# Sheraton Hotel & Event Center

## Detailed Information for Exterior Enhancements Price Breakouts

These exterior enhancements were included in the current scope at the request of the City of McKinney, and are above and beyond initial requirements. Pricing for each item is needed to substantiate the added costs to the project. Please note that some items could be removed from the program, and thus the pricing would be deducted from the submitted program and price. The following pages outline each of these enhancements, and correspond to a line item on the bid tab for the breakout pricing.

## J. Add Canopy at Courtyard Entry

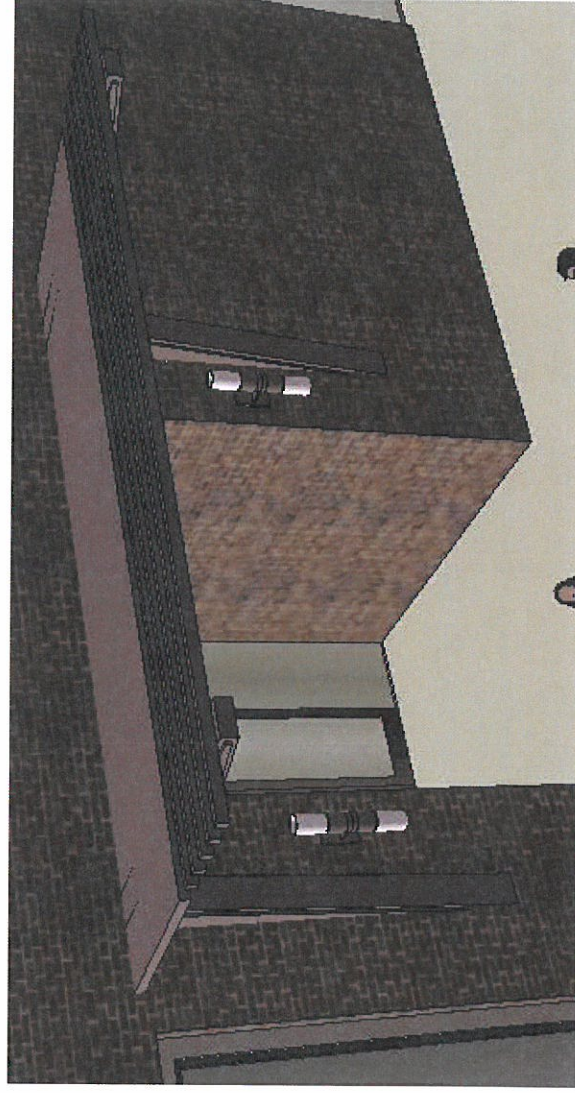
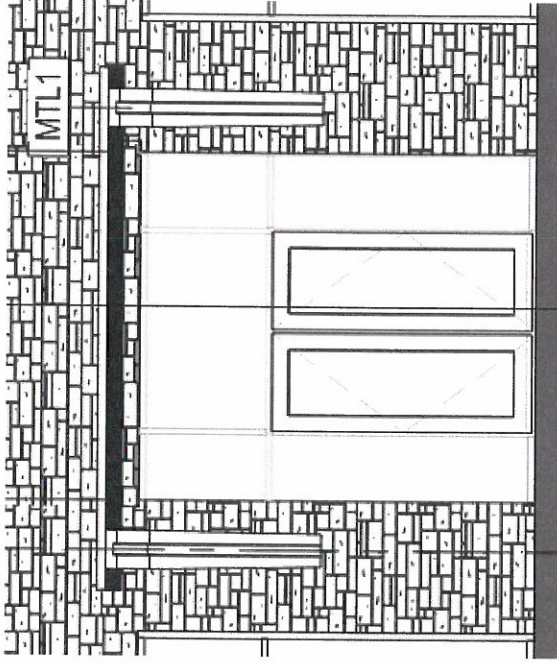
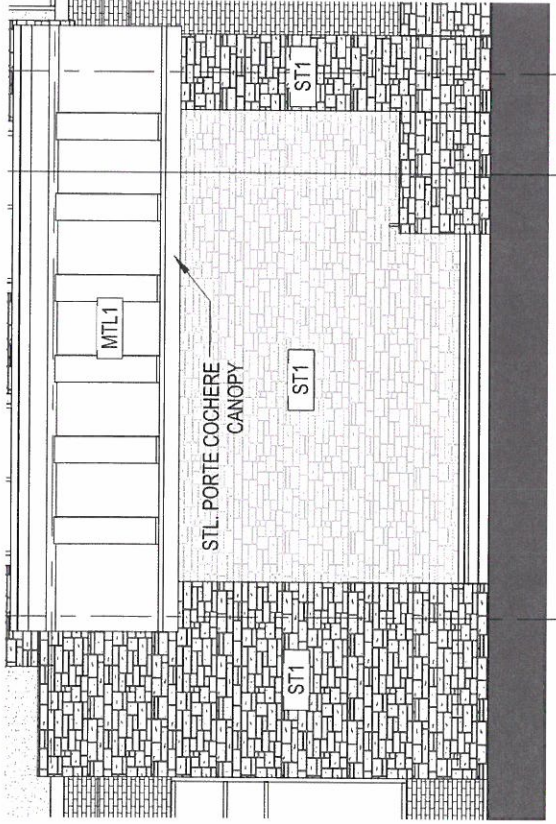
- All items associated with canopy to be included.
- Steel supports inside building not yet shown.

**K. Change Main Entry Exterior Materials**

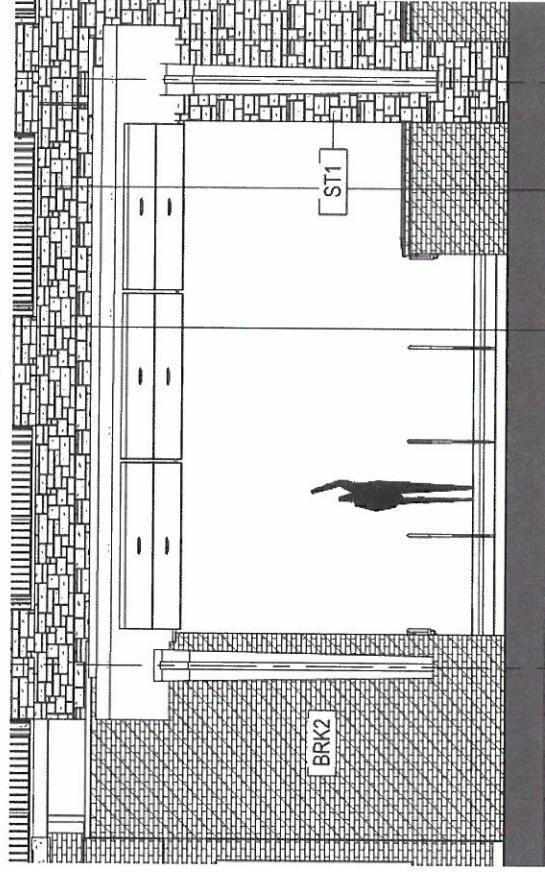
- Brick to stone veneer revisions
- Stone veneer to brick revisions
- Stone to wood panels
